**DEPARTMENT OF TRANSPORTATION
STATE OF GEORGIA**

SUBJECT: IMPLEMENTATION OF VALUE ENGINEERING STUDY ALTERNATIVES

RE: I-285 @ CR 4519/Atlanta Road Interchange
STP00-0222-01(001), Cobb County
P.I. No. 752300
Value Engineering Study Responses

**I-285 @ ATLANTA ROAD
INTERCHANGE RECONSTRUCTION**
ALTERNATE 2 - PREFERRED ALTERNATE

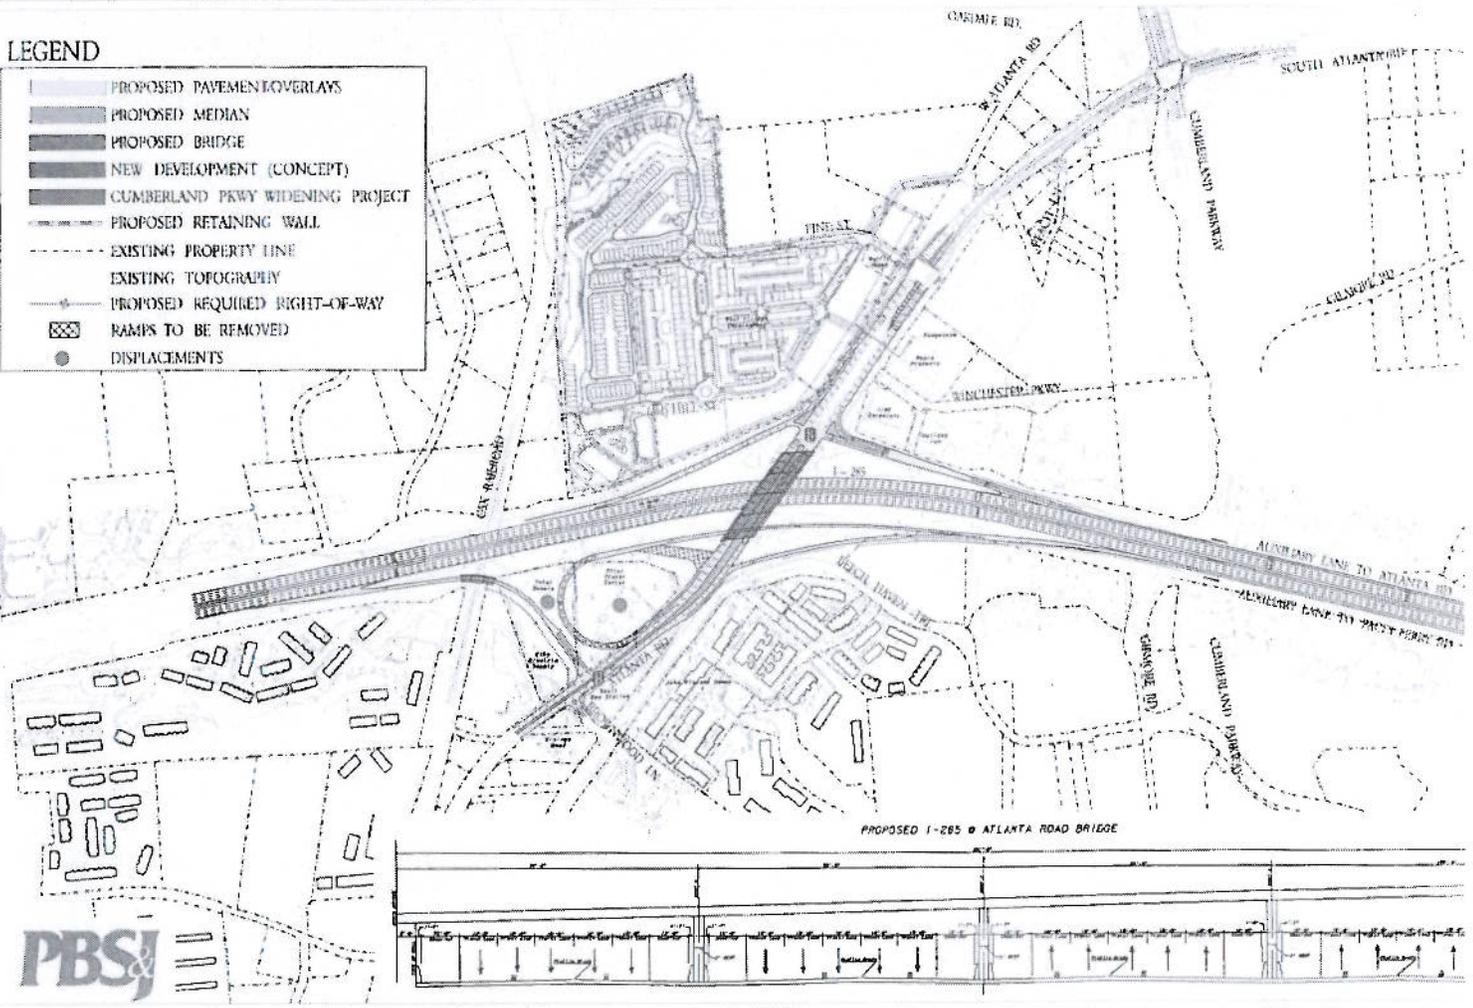
Alternate 2 is a partial diamond/partial cloverleaf interchange with a loop ramp located in the SE quadrant. The construction of the loop ramp would require two displacements. Alternate 2 was the alternate preferred by Cobb County, prior to the VE Study.

Alternate 4 is a tight urban diamond interchange. No displacements have been identified with this alternate at this time. After the VE Study was held, a decision was made to utilize the TUDI, and Alternate 4 is now the preferred alignment.
